AGENDA
President and Board of Trustees
Village of Arlington Heights
Board Room

A. Chase Bank - 585 E. Palatine Rd. - PC#23-014

Amendment to Ordinance 84-10, Special Use Permit for Bank with Drive-Thru, Variation

SITE PLAN

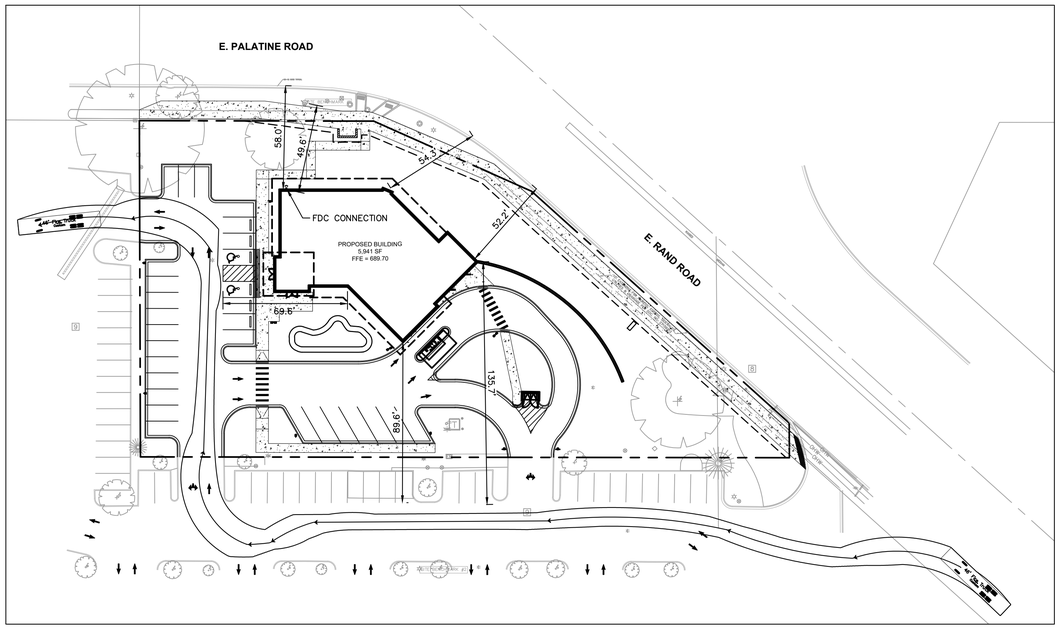
34. The response to comment #21 is not sufficient. The details on the architectural elevation sheet does not match the canopy size outlines on the site plan (sheet C2.0). It is unclear what is being proposed in this location. Please provide details necessary to understand what is being proposed. Will the canopy adjacent to the building be free-standing or attached to the building? Provide an accurate detail for the proposed canopies, or reduce the size of the canopies shown on C2.0 to match was is shown on the elevation page. The Village needs to understand whether a variation is required.

36. The response to comment #24 is noted. Please be aware that the label on sheet C2.0 that points to the bike rack has been mis-numbered and should be labeled 17, not 16.

Response: The aisle widths are confirmed to be 25-ft from face of curb to face of curb or from the end of parking stalls. Please see sheet C2.0 for revised pavement hatching.

Response: Comment acknowledged. Pavement sections have been provided on sheet C2.0.

Response: Comment acknowledged. We are showing an amended sidewalk easement for the proposed 10-ft wide sidewalk along Rand Road. Please see sheet C2.0.

Response: The 10' multi-use pathway has been tapered down at the NW corner. Truncated domes at the SE terminus have been included. Please see site plan sheet C2.0.

Response: The parking and landscape islands as mentioned in the comment have been revised to comply with the code. Please see sheet C2.0. Site layout revised in landscape plans to include parking islands with tree at SE corner. The two parking stalls just east of this were removed to eliminate this tree requirement.

Response: The proposed bike parking stalls have been added. Please reference sheet C2.0 for location.

34. The response to comment #21 is not sufficient. The details on the architectural elevation sheet does not match the canopy size outlines on the site plan (sheet C2.0). It is unclear what is being proposed in this location. Please provide details necessary to understand what is being proposed. Will the canopy adjacent to the building be free-standing or attached to the building? Provide an accurate detail for the proposed canopies, or reduce the size of the canopies shown on C2.0 to match was is shown on the elevation page. The Village needs to understand whether a variation is required.
Response: Acknowledge. Revised drawings have been provided in submittal package.

36. The response to comment #24 is noted. Please be aware that the label on sheet C2.0 that points to the bike rack has been mis-numbered and should be labeled 17, not 16.
Response: Acknowledge. Revised drawings have been provided in submittal package.

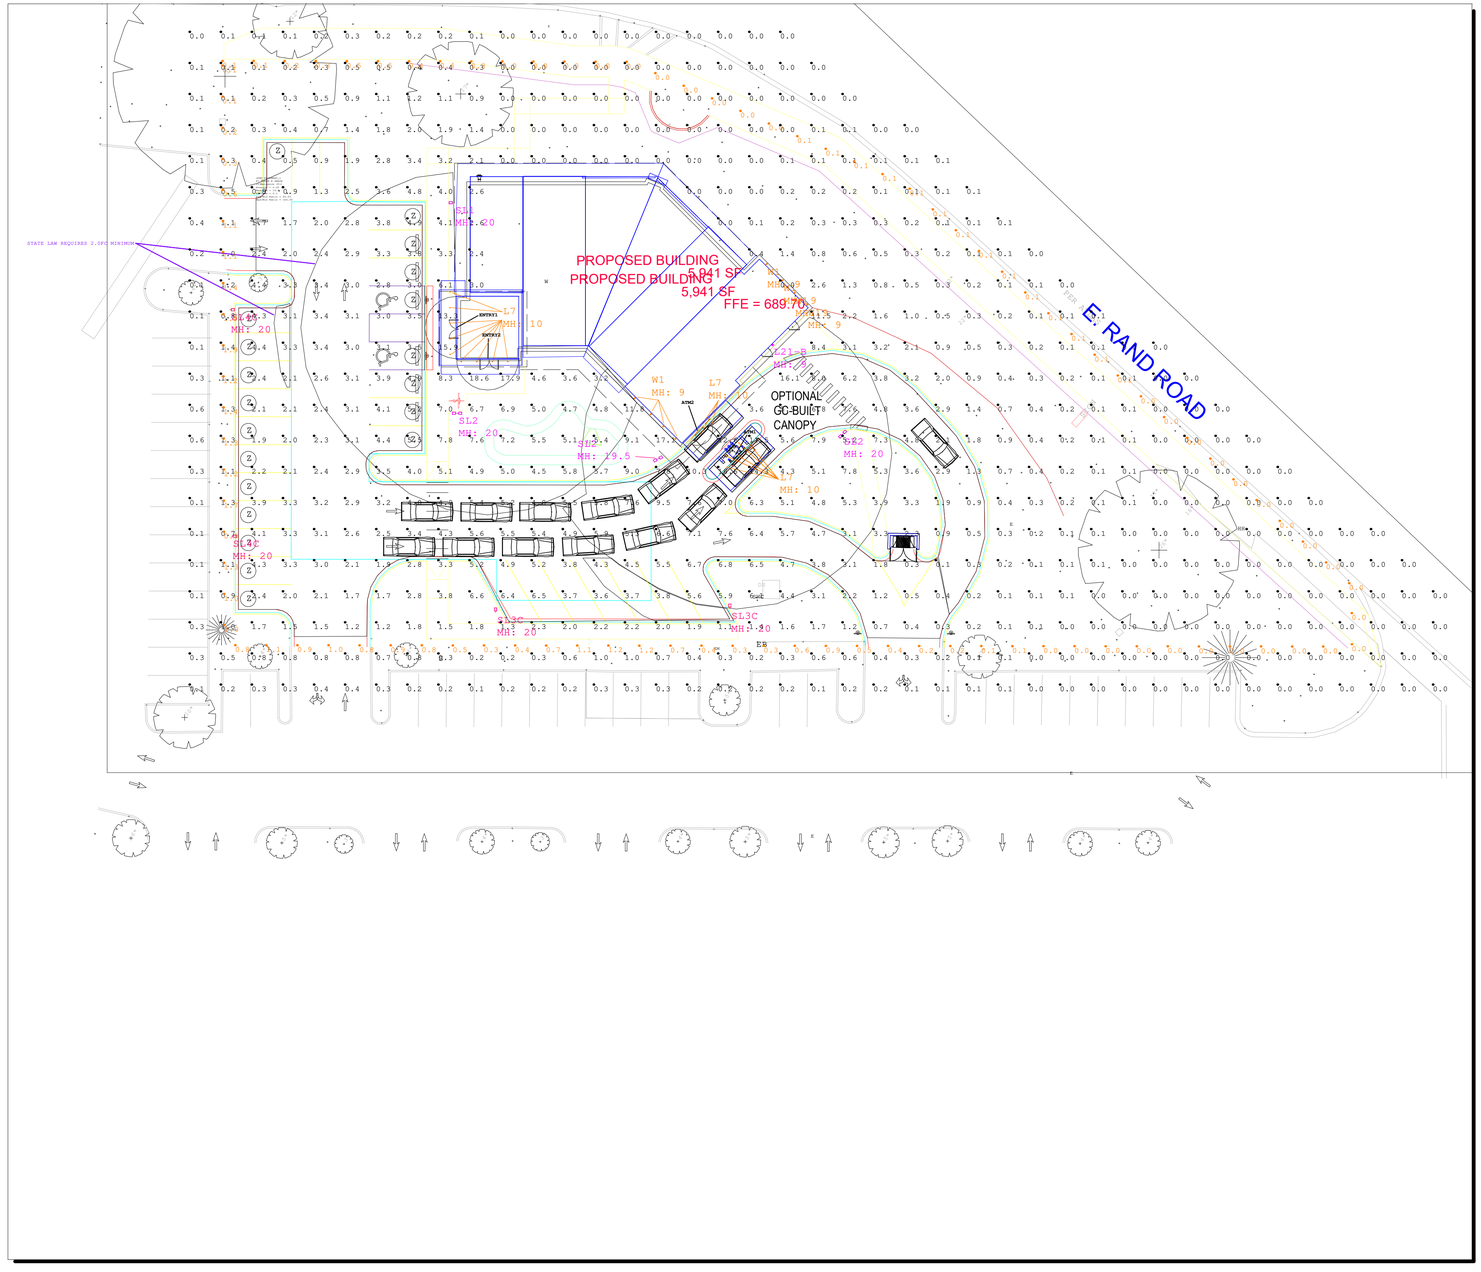
18. Per Section 10.2-12.c.3, all light poles that are between 20'-40' in height shall be separated by 3' for every 1' of fixture mounting height. Please provide the proposed mounting heights for fixtures SL1 and SL2 and revise the pole locations accordingly. Additionally, please confirm that the pole locations, as shown on sheet C.1, are accurate and not approximate.

18. Per Section 10.2-12.c.3, all light poles that are between 20'-40' in height shall be separated by 3' for every 1' of fixture mounting height. Please provide the proposed mounting heights for fixtures SL1 and SL2 and revise the pole locations accordingly. Additionally, please confirm that the pole locations, as shown on sheet C.1, are accurate and not approximate.
    Response: Photometric proposed plan has been revised.
